STAFF RECOMMENDATION
116 Mockingbird Road
April 18, 2012

Application: New construction – Accessory structure
District: Cherokee Park Neighborhood Conservation Zoning Overlay
Council District: 24
Map and Parcel Number: 10312023900
Applicant: Douglas Linfert, Owner
Project Lead: Sean Alexander, sean.alexander@nashville.gov

Rear

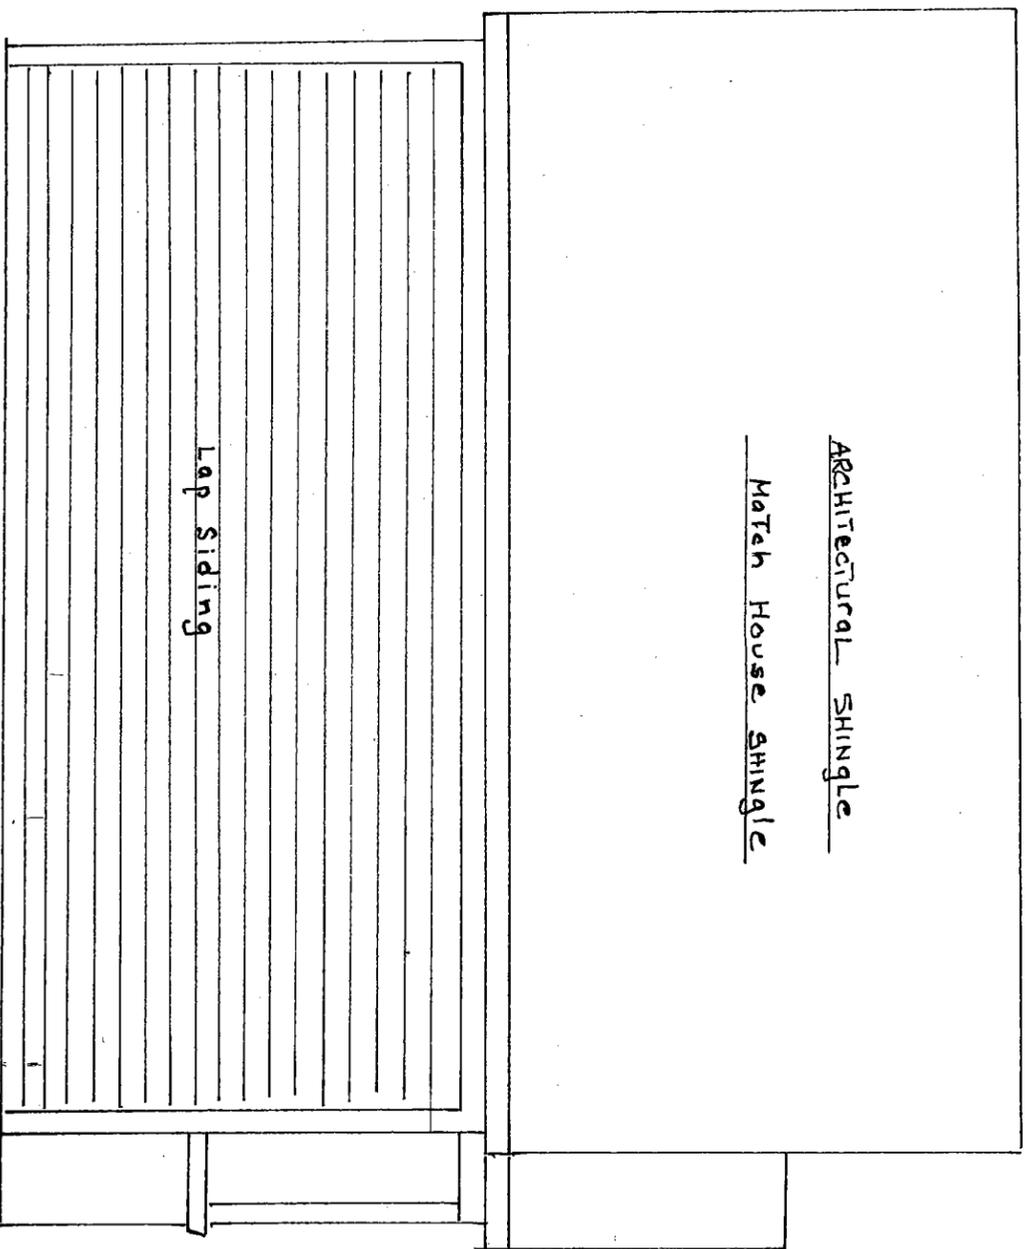
The roof of the structure will be twenty-two (22') feet above grade, with an eave line at ten feet (10') above the floor level. These proportions match the roof and eave heights of the house, but the perceived massing of the garage will be reduced because the grade drops three to four feet (3' to 4') from the house to the back of the lot. The scale and height of the structure are compatible with surrounding accessory structures and meet guidelines II.B.1.a and II.B.1.b.

The walls of the structure will have decorative half-timbering with stucco to match the materials of the existing structure. The rear walls of the structure may have cement-fiber clapboard siding, which would also be compatible. The foundation will be concrete (slab), and the roof will be fiberglass-asphalt shingles to match the house. The vehicle doors and front-facing pedestrian door will be metal, and will reflect to character of the house. There will be wooden windows in the dormer and above the pedestrian door. These materials meet guideline II.B.1.d.

The roof of the garage will be a front-oriented gable with a 12:12 pitch, matching the pitch of the primary structure. This will be compatible with surrounding historic structures and will meet guideline II.B.1.e. There will be a shed-roofed dormer facing the interior of the lot, obscured from the right of way by the house.

The submitted floorplans show a full bathroom in the upperstory of the structure, which would only be permitted if a Detached Accessory Dwelling Unit Covenant were filed. The applicant has informed Staff that they intend to eliminate the shower fixture in order to meet Zoning requirements for non-dwelling accessory structures,

Staff recommends approval of the application to demolish the existing carport and construct a new two-car garage, finding the scale, location, and materials of the new structure to be compatible with surrounding structures and to meet the Cherokee Park Neighborhood Conservation Zoning Overlay design guidelines.
